The purpose of this report is to present Council with information, analysis and recommendations for an Official Community Plan Amendment Application and a Rezoning Application for the property located at 1146 Caledonia Avenue. The proposal is to rezone the property from the R-2 Zone (Two Family Dwelling District) to a new zone to increase the density to 0.86:1 floor space ratio (FSR) and permit a six-unit multiple dwelling.

RE: 1146 Caledonia Avenue revised proposal for Official Community Plan Amendment, Rezoning and Development Permit Application.

In response to the Application Review Summary dated Wednesday, January 14, 2015, we are pleased to submit our revised proposal for the above noted development. The subject of this letter is to provide an itemized update and clarification of new information on the proposal and should be reviewed in conjunction with the revised, bubbled drawings.

Basement & Main Floor Plan

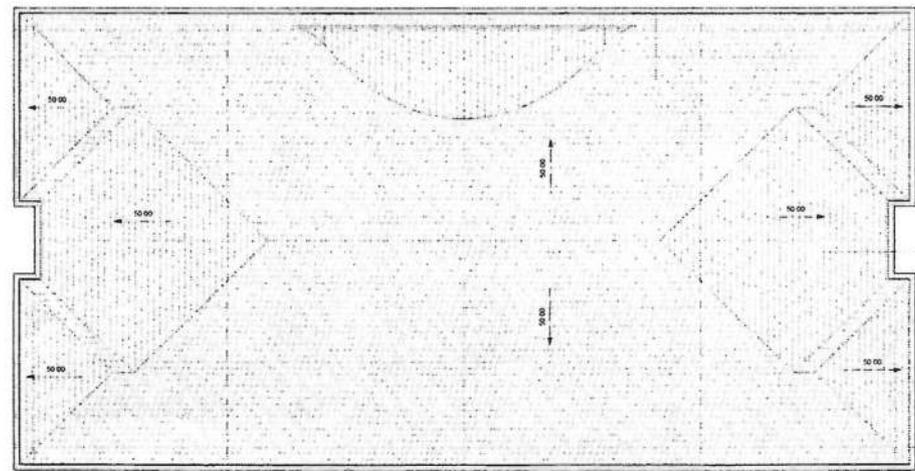
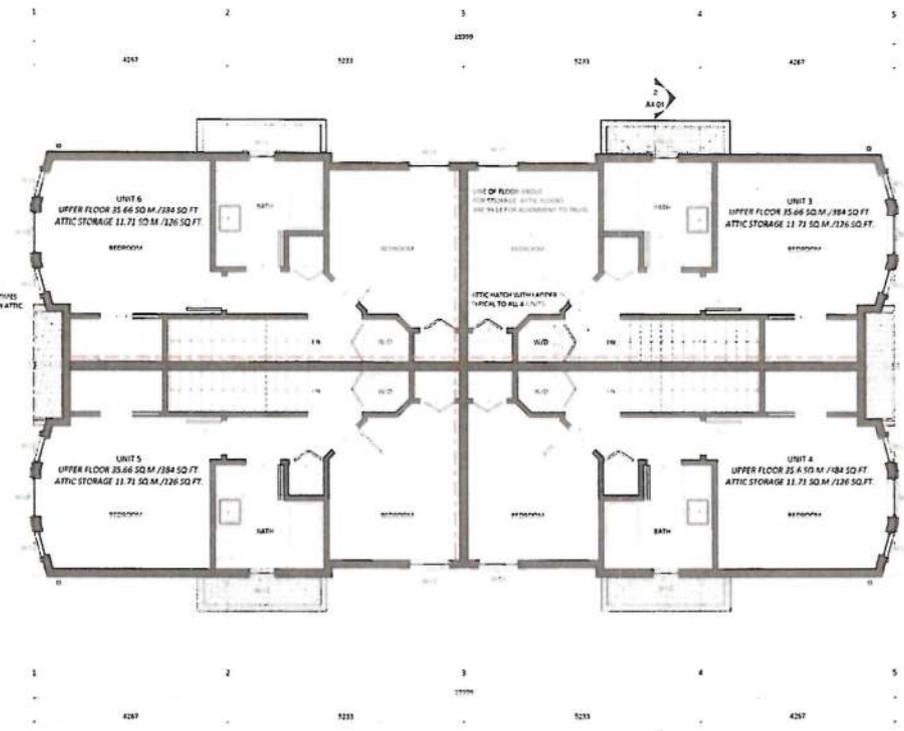
3. Please reduce the building footprint, to achieve the following:

- **Increased front yard setback that aligns with the pattern of setbacks along the east side of this block of Caledonia Avenue.**
- **Increased rear yard to provide more outdoor space for the rear apartments.**
- **Increased west setback to ensure privacy of the neighbours is protected.**
- **Increased east setback to provide more private outdoor space (patio/garden).**

The building location has been governed by the fixed dimension of proposed parking stalls in addition to the north statutory right of away. The west setback has been determined by the exiting at basement level by a minimal projection while the remainder of the building is set further back on all levels. The east setback allows for approximately 8'-0" + of private outdoor space.
